# 1014 — Space For Ideas

## Community board 8 hearing

Certificate of Appropriateness Application  
no. #M00746664-I1

# **Proposed amendments to approved design**

# Window

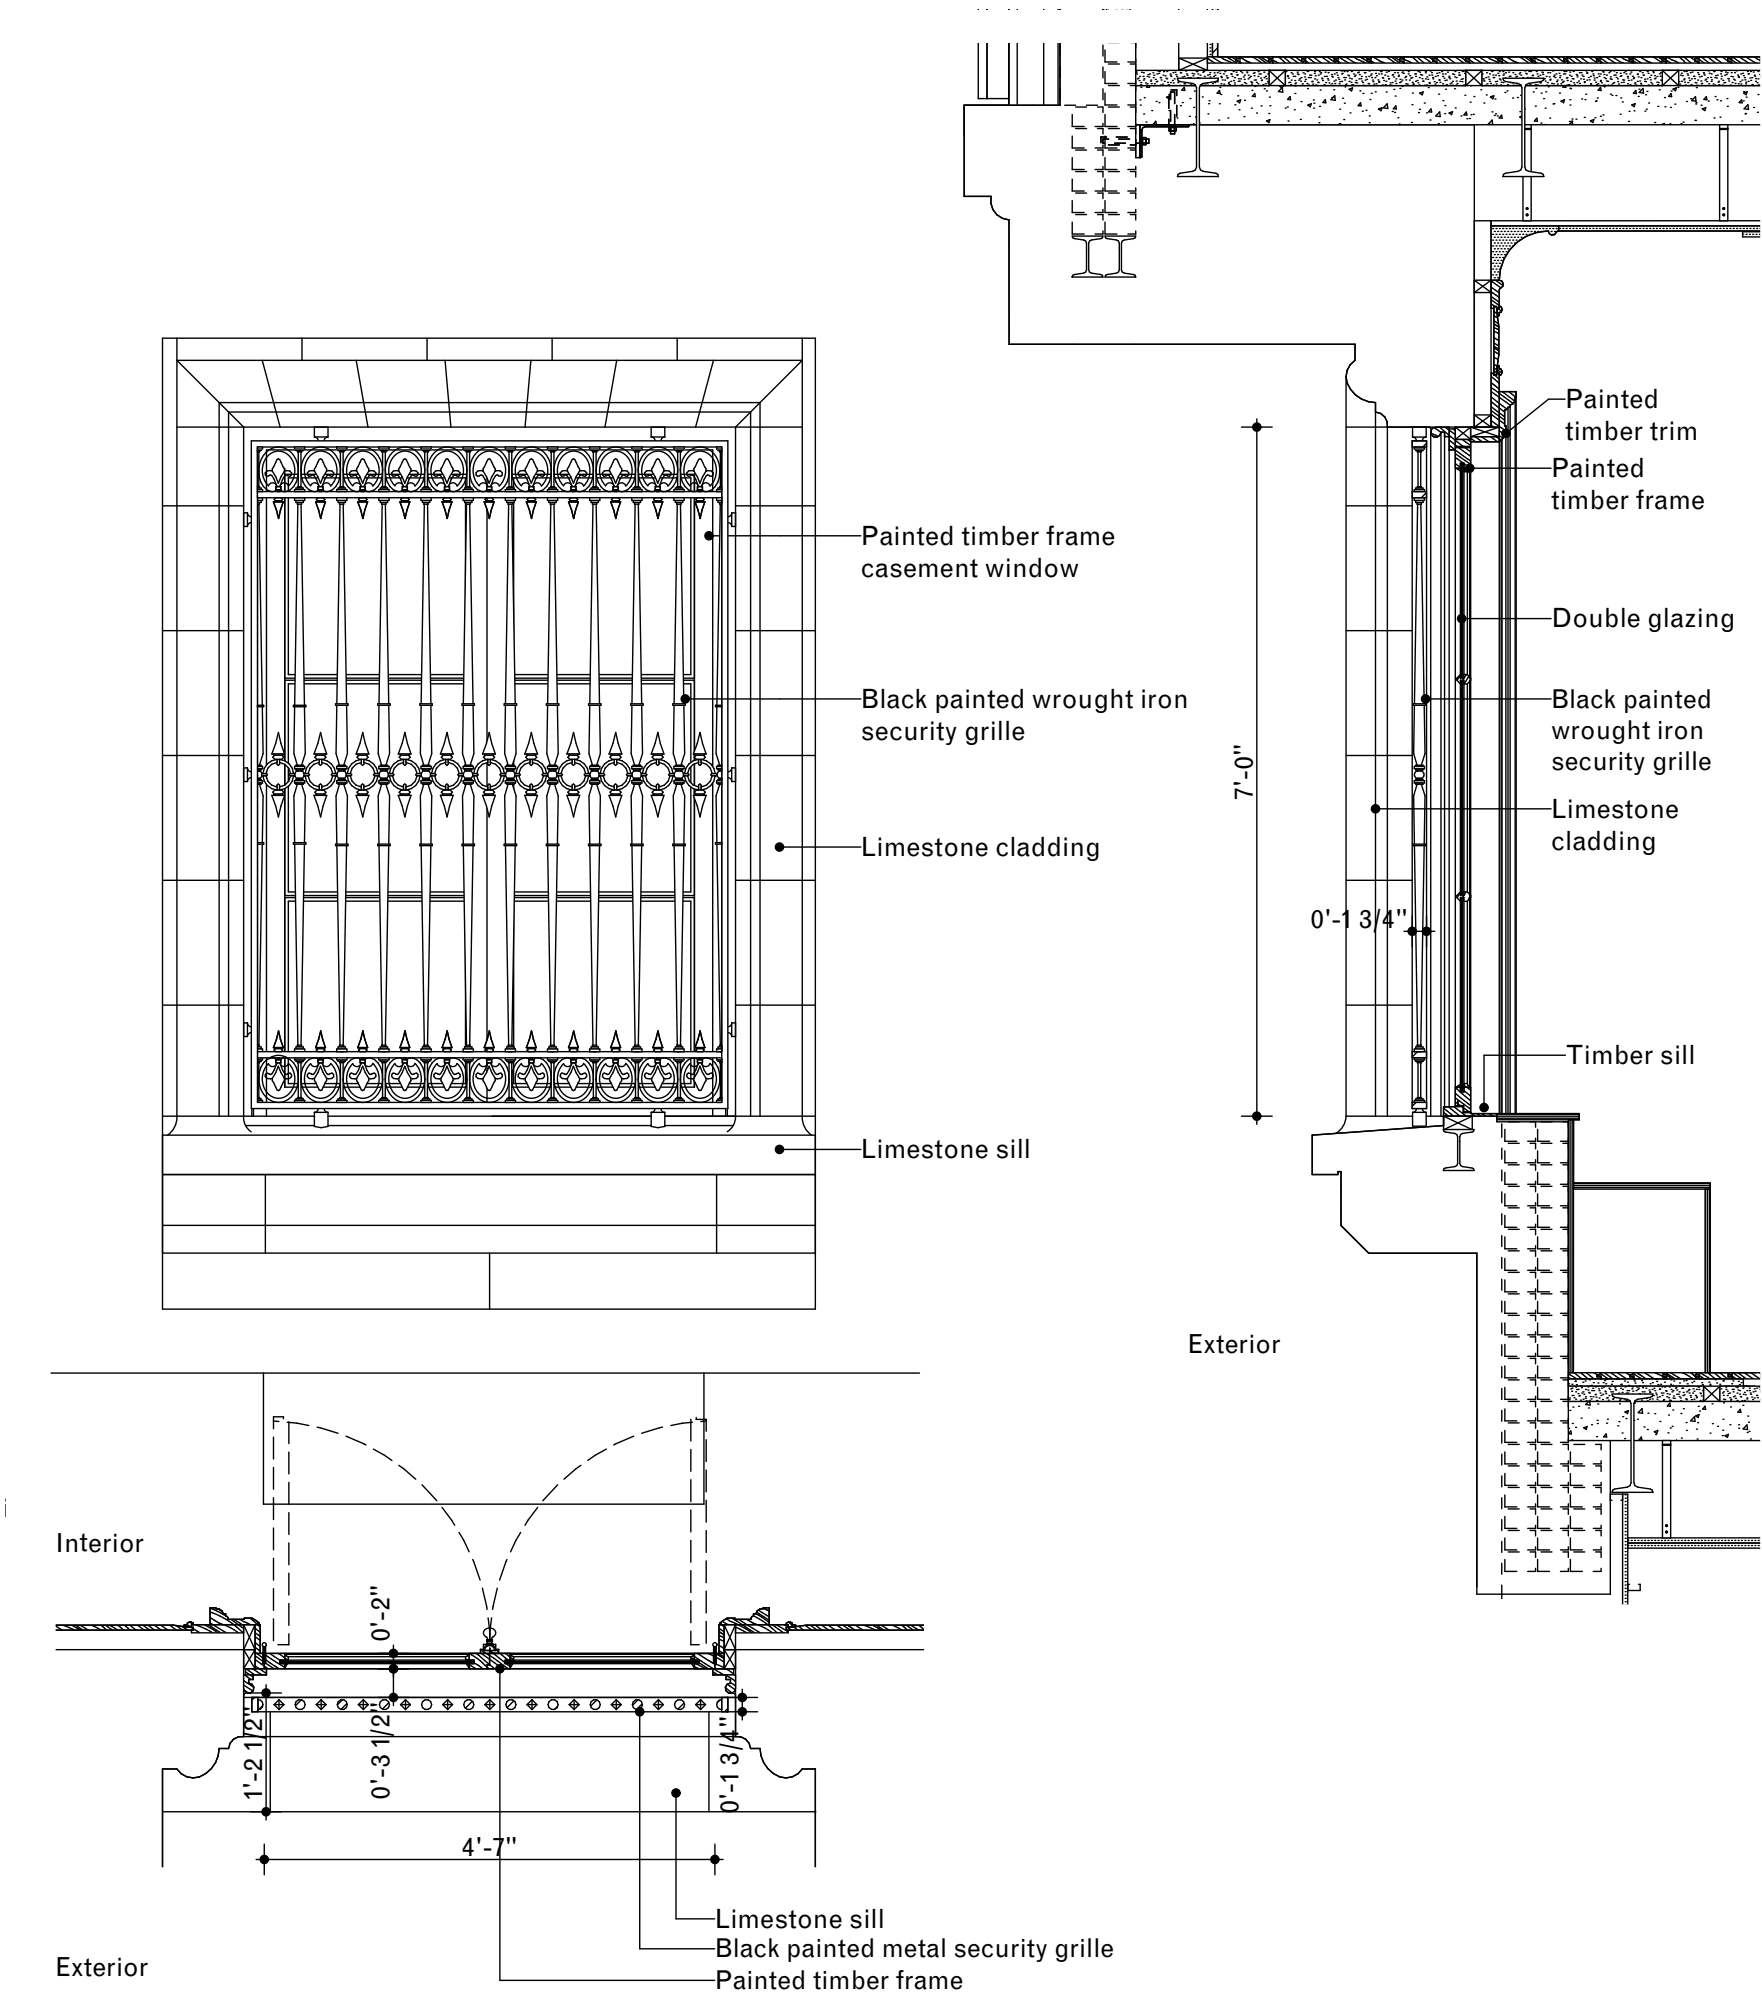
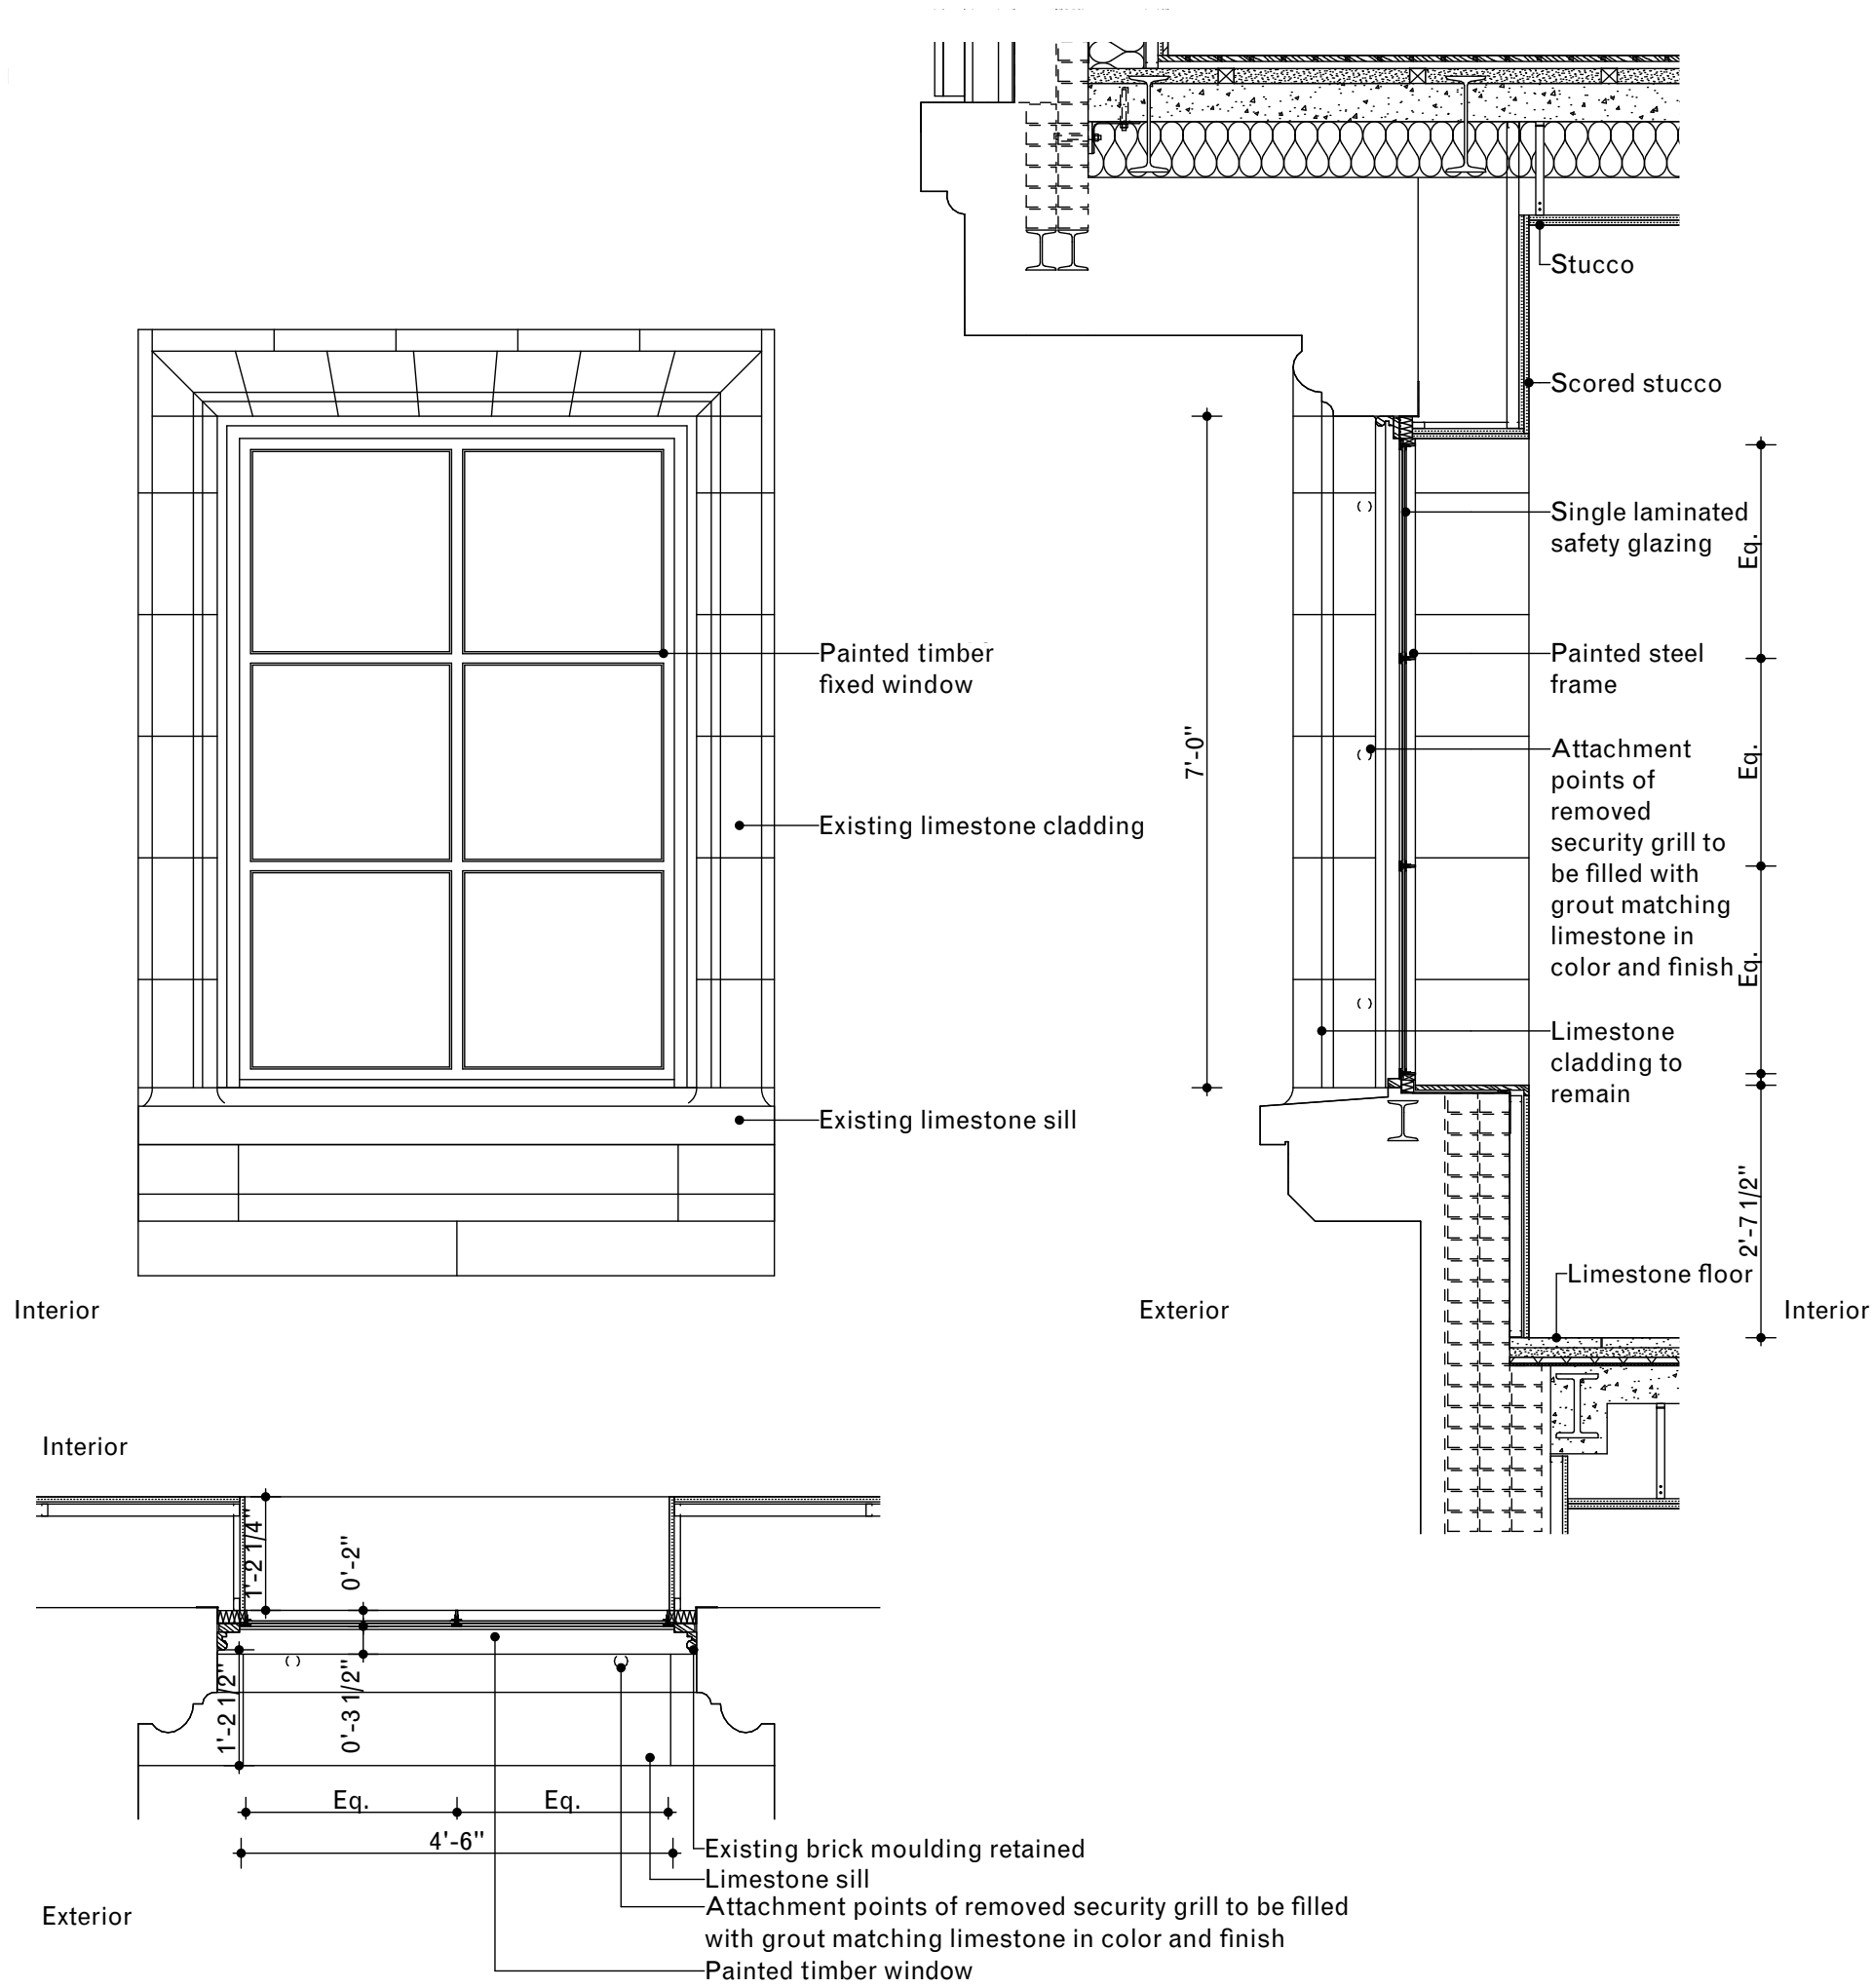
Existing timber window and security bars replaced by new fixed painted timber window

# Proposed signage

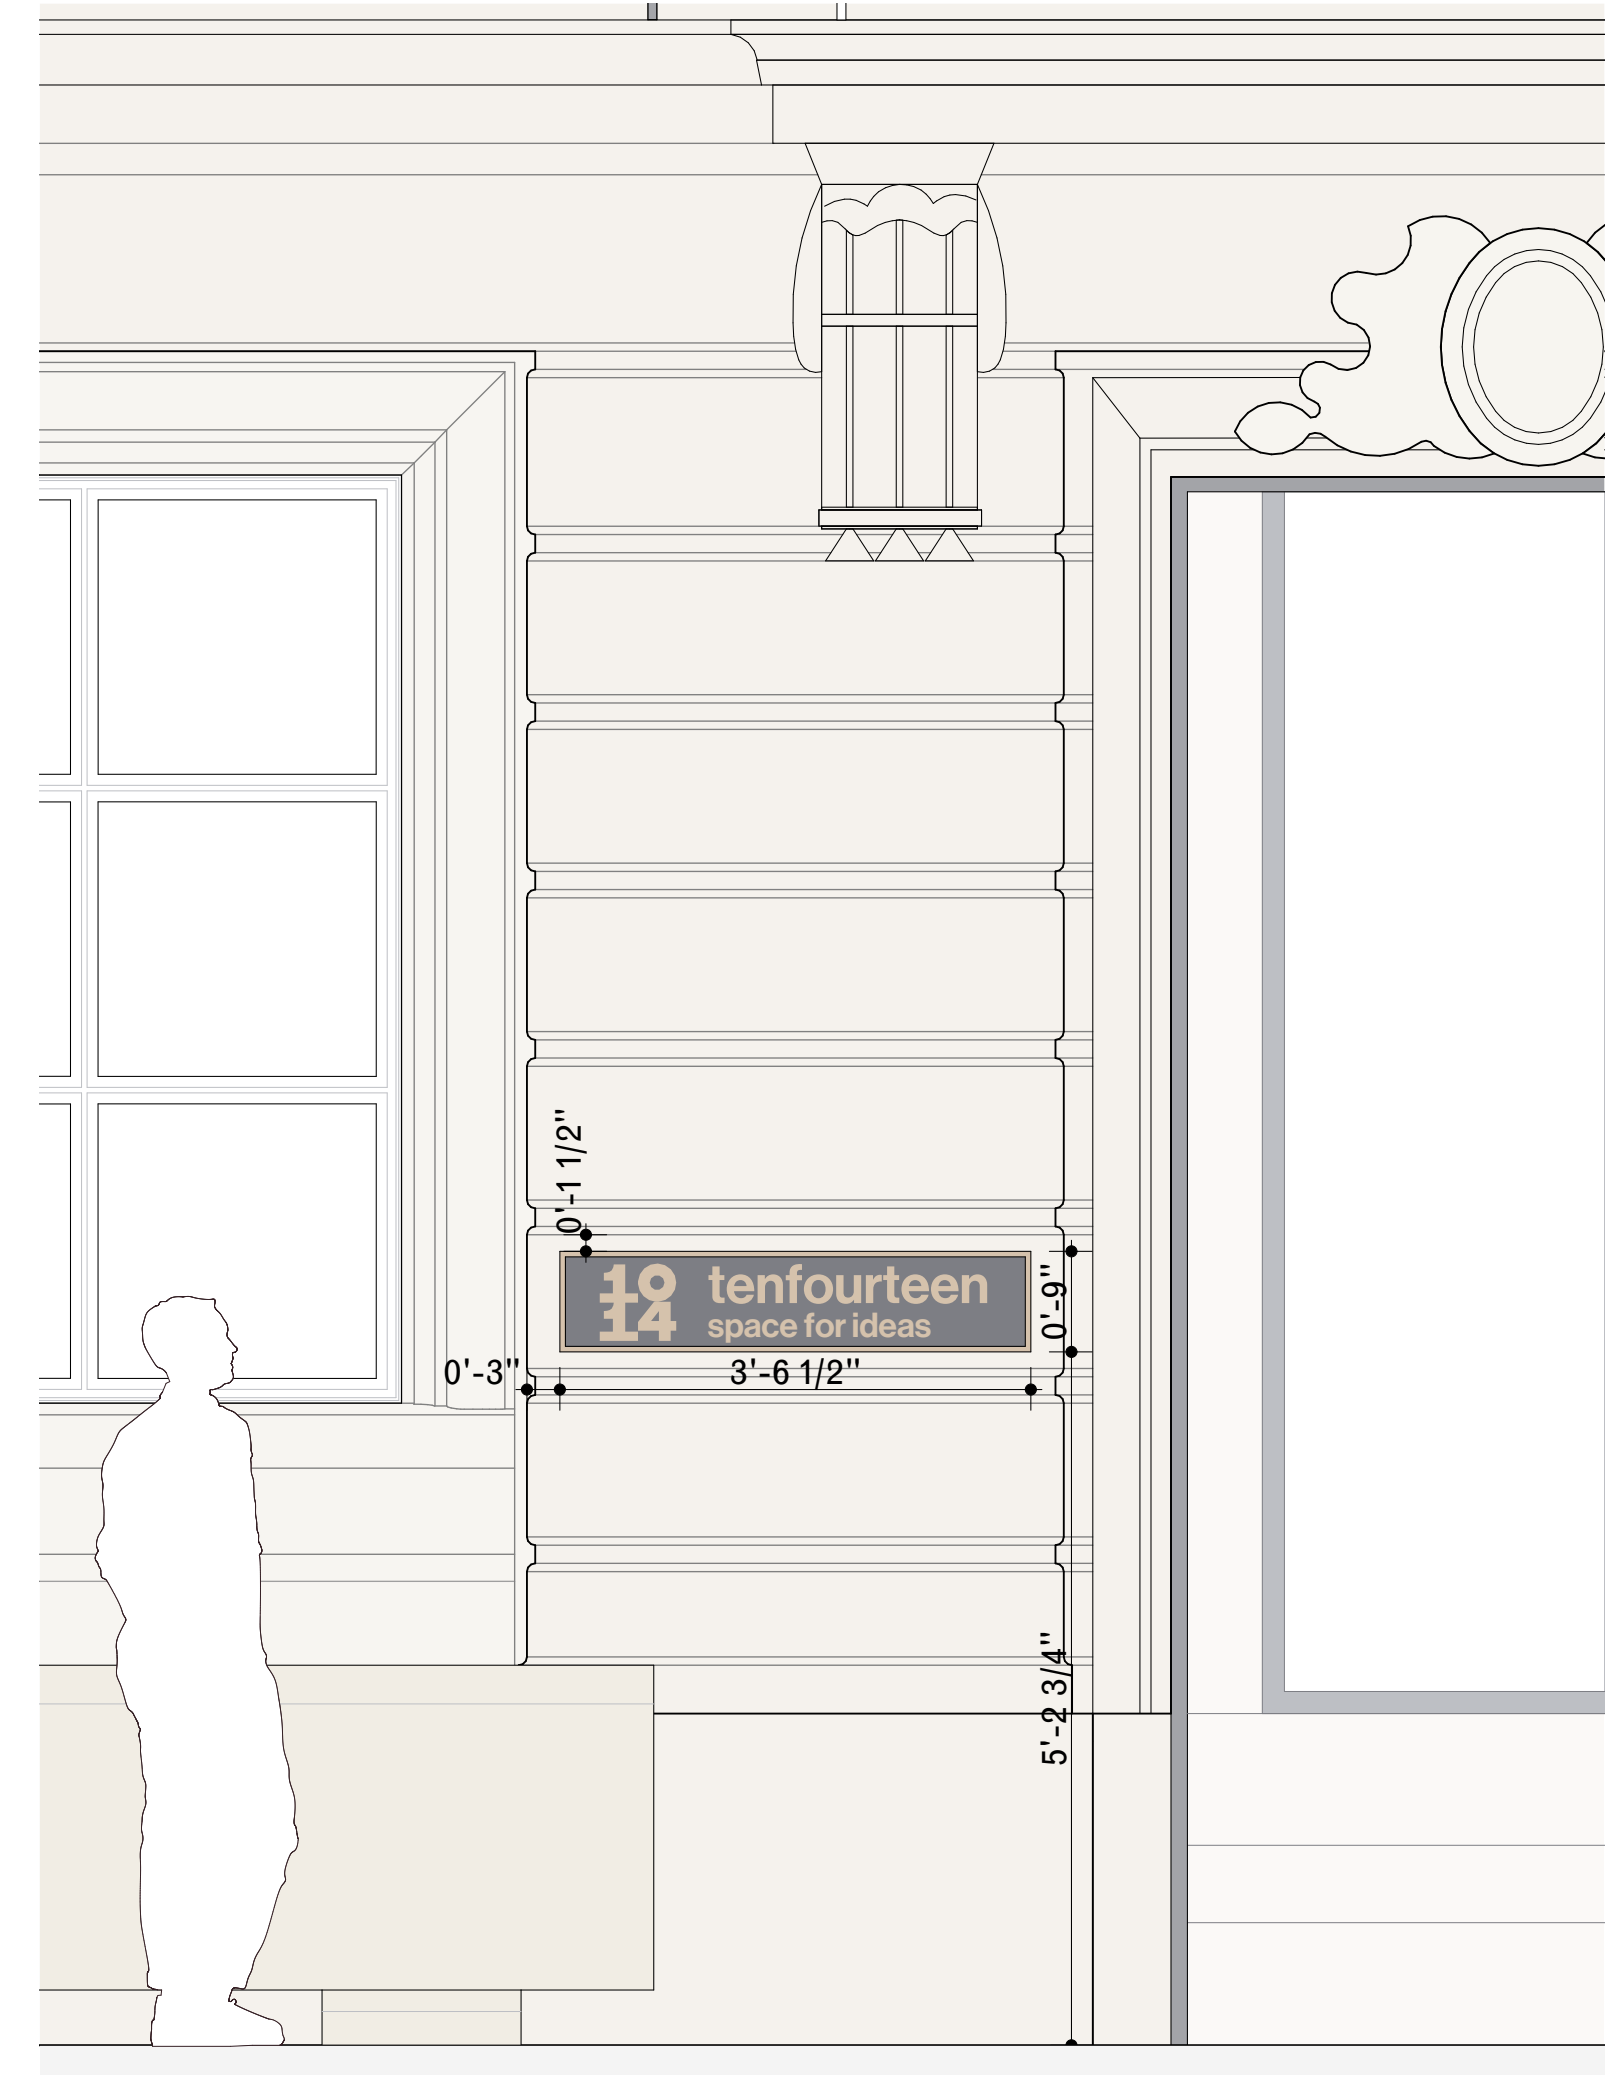
- New metal plaque would re-use former Goethe House plaque fixings
- Seeking approval for sign location, detail and graphics refinement to be developed further
